Access Compliance Report

Public Rights-of-Way

Intersection ID: N/A	Main Street: E 8TH ST	Cross Street: N BREVARD ST	Location: S
ADA ID: ABFE00B3E2C9	Ramp Type: Perp	Initial Pass/Fail: Fail	Overall Compliance: No
		Severity Score: 1.25

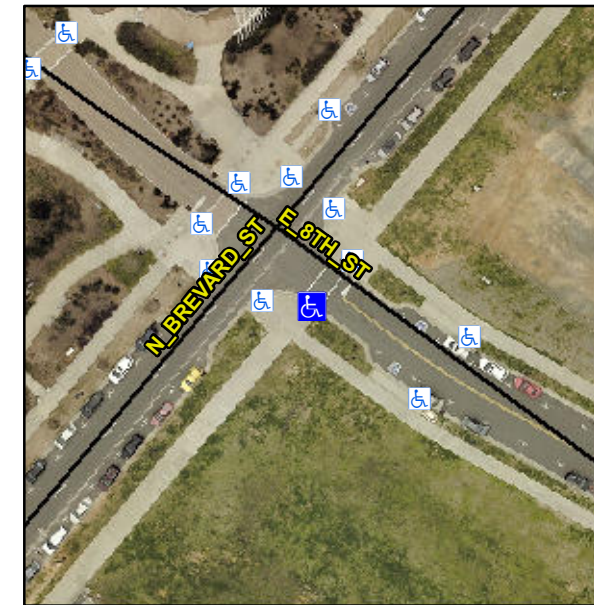
R304.5.3

Compliance	Description	Data	Compliance	Description	Data
N/A	Ramp Length (in)	78.5	Yes	Ramp Slope (%)	6.1
Yes	Ramp Width (in)	48.0	No	Ramp XSlope (%)	4.1
N/A	Flare Type LT	N/A	N/A	Flare Type RT	N/A
N/A	Flare Slope LT (%)	N/A	N/A	Flare Slope RT (%)	N/A
N/A	Flare Traversable LT?	No	N/A	Flare Traversable RT?	No
N/A	Landing Length (in)	N/A	N/A	DWS Provided?	N/A
N/A	Landing Width (in)	N/A	N/A	DWS Contrast?	N/A
N/A	Landing Slope (%)	N/A	N/A	DWS Length (in)	N/A
N/A	Landing X Slope (%)	N/A	N/A	DWS Full Width?	N/A
N/A	Landing Curb? (Y/N)	N/A	N/A	DWS Offset (in)	N/A
N/A	Shared Landing?	N/A			
N/A	Gutter Ponding?	N/A	N/A	Gutter Slope (%)	N/A
N/A	Gutter Lip Ht (in)	N/A	N/A	Gutter X Slope (%)	N/A
N/A	Painted X Walk1?	Yes	N/A	Painted X Walk2?	N/A
	X Walk 1 Direction	To NE		X Walk 2 Direction	N/A
N/A	X Walk 1 Width (in)	111.0	N/A	X Walk 2 Width (in)	N/A
	X Walk 1 Slope (%)	2.0		X Walk 2 Slope (%)	N/A
	X Walk 1 X Slope (%)	4.5		X Walk 2 X Slope (%)	N/A

Remove & Replace Entire Ramp.
